FAIRMAN et al.
Application No. 09/555,929
March 22, 2004

AMENDMENTS TO THE DRAWINGS:

Figure 2

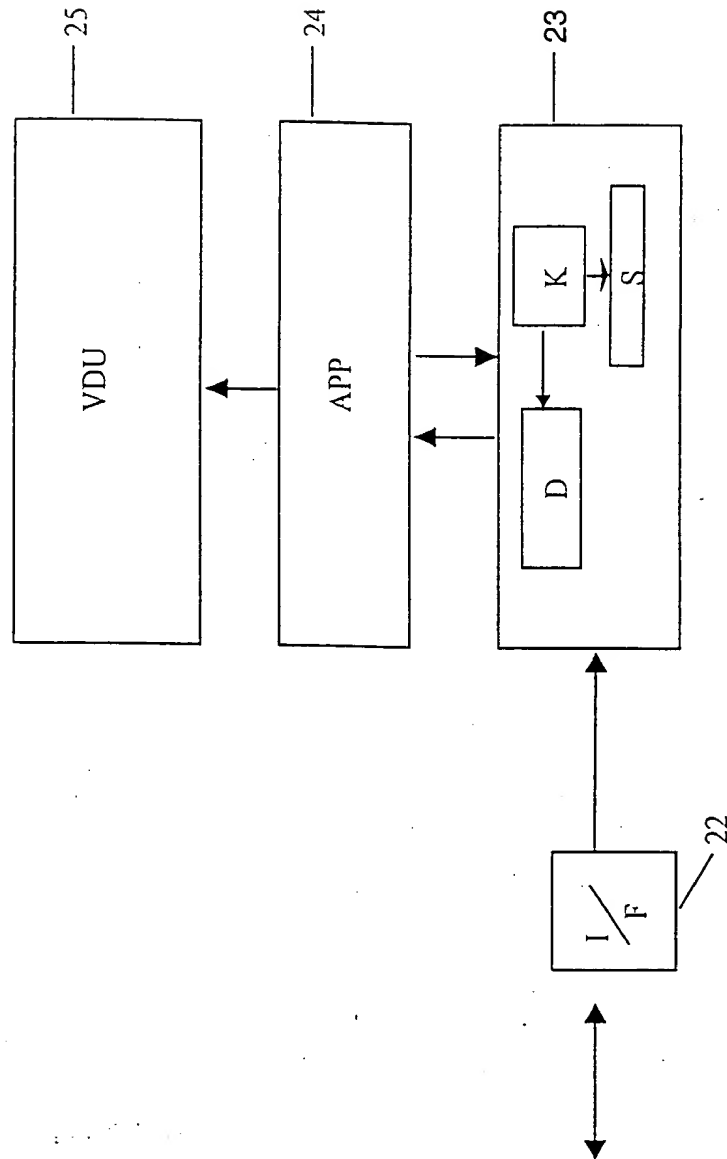
The attached sheet of drawings includes changes to Fig. 2. This sheet replaces the original sheet including Fig. 2. In Fig. 2, label “33” has been changed to “23” so that it is consistent with the written specification.
